(License Renewal for the Oyster Creek  
Nuclear Generating Station) )

\_\_\_\_\_  
**CITIZENS' SUPPLEMENTAL BRIEF REGARDING COMMISSION QUESTIONS ON  
STRUCTURAL ANALYSIS AND BOARD FOLLOW UP QUESTIONS**  
\_\_\_\_\_

Subject: **Comments On AmerGen's Modeling Proposal**

**Figure 1**

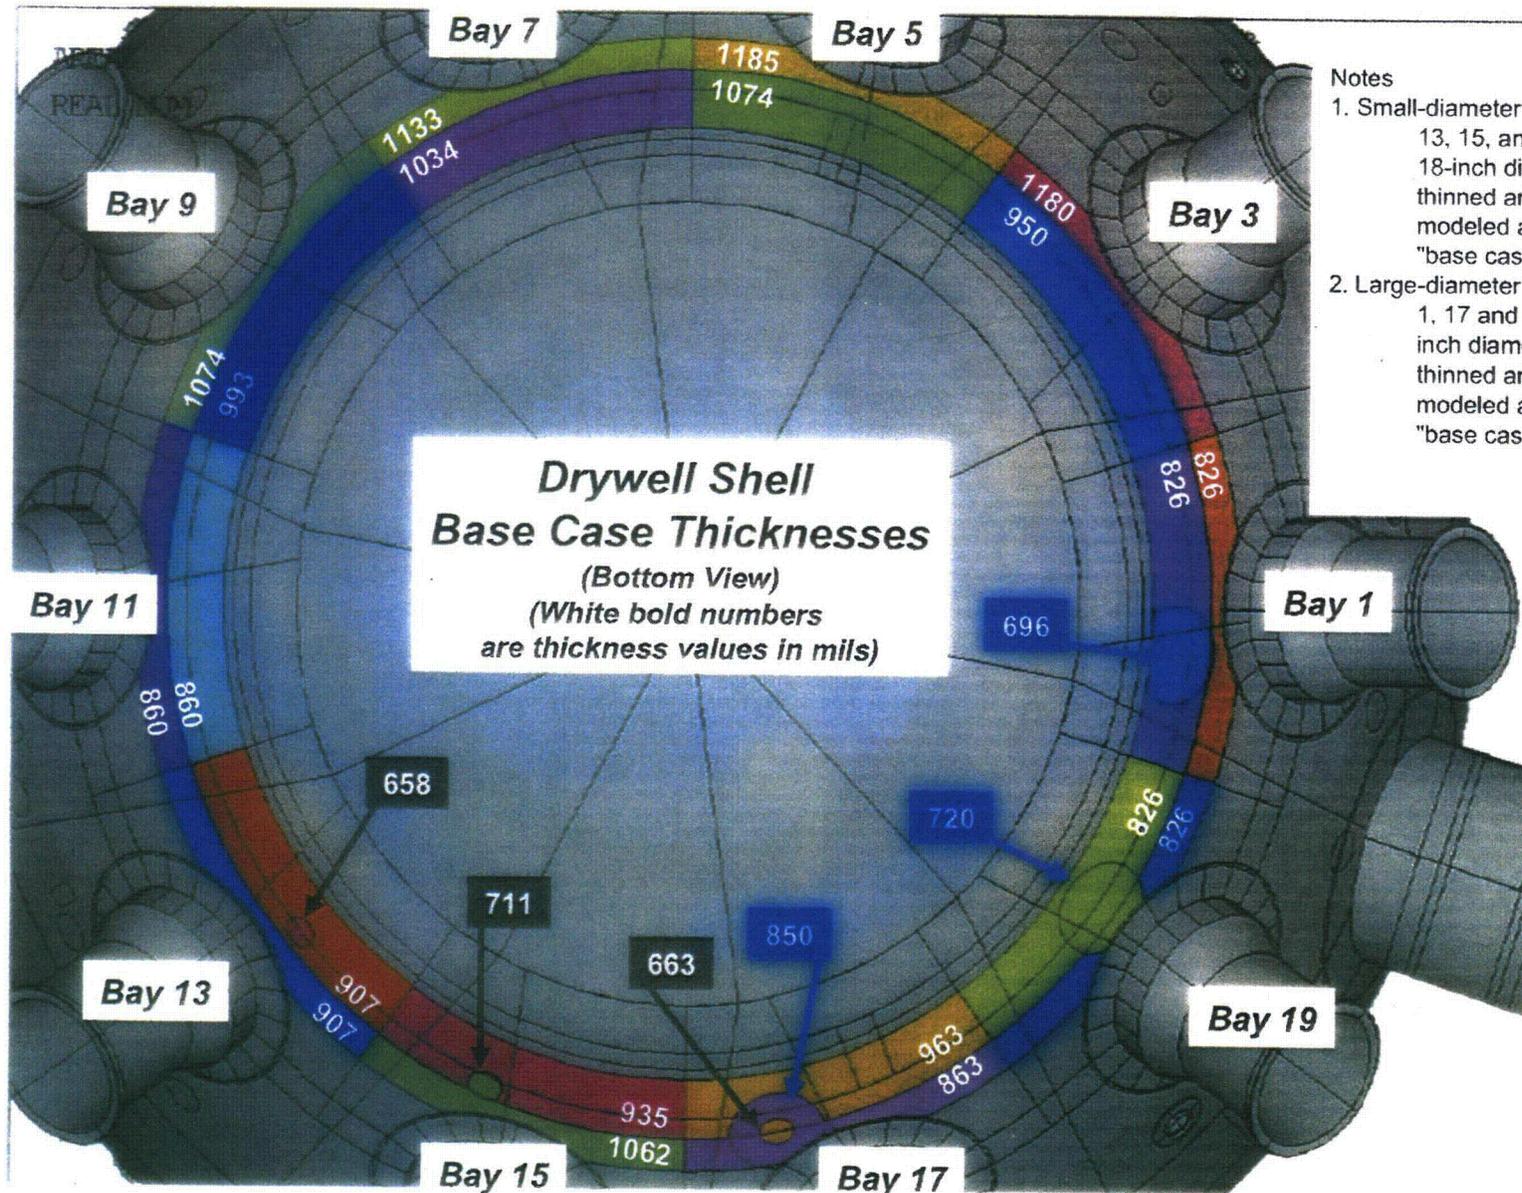
Figure 1 attached provides AmerGen's proposed inputs to the required 3D analysis of the drywell shell. Using the visual observations and direct measurements of the residual wall thicknesses, this memo shows that this proposal is entirely inadequate because it results in a surface that is unrealistically smooth and excessively thick. In addition, the proposed sensitivity analyses completely fail to capture the full range of uncertainty regarding the thickness of the sandbed region.

AmerGen's currently proposed model shows two horizontal rings. The higher elevation is essentially defined by the grid measurements, and the lower one in the sandbed region defined by the some adjusted estimate of the average of either the internal or external UT measurements. The data are summarized in Figure 1.

The average and locally thin areas selected by AmerGen shown in the Figure 1 are not consistent with the external data. For example, in Bay 1 points 14 and 15 were chosen to confirm that no corrosion had

AmerGen's base case assigns 826 mil to both rings. The average from grid data is 1068 mil and from the external measurements 767, if point 14 and 15 are omitted because they were chosen to be uncorroded. AmerGen's proposed average is simply the grid averages from the adjacent Bay 19. AmerGen then also places a circle of lower than average corrosion in the lower part of Bay 1 with an average of 696 mil vs. the average of 767 mils from the external UT data. The 51 inch diameter however does not even cover the measured area of severe corrosion. Furthermore, a detailed analysis shows that the extent of corrosion is in all likelihood much larger than the 51 inch circle would suggest. See also Citizen's Exh CR 4, Figs 2 through 13 discussed above. The data therefore suggest that the average for the lower area is 767 vs. 826 mils and the documented history suggest strongly that the corroded area is much larger than covered by the 51 circle.
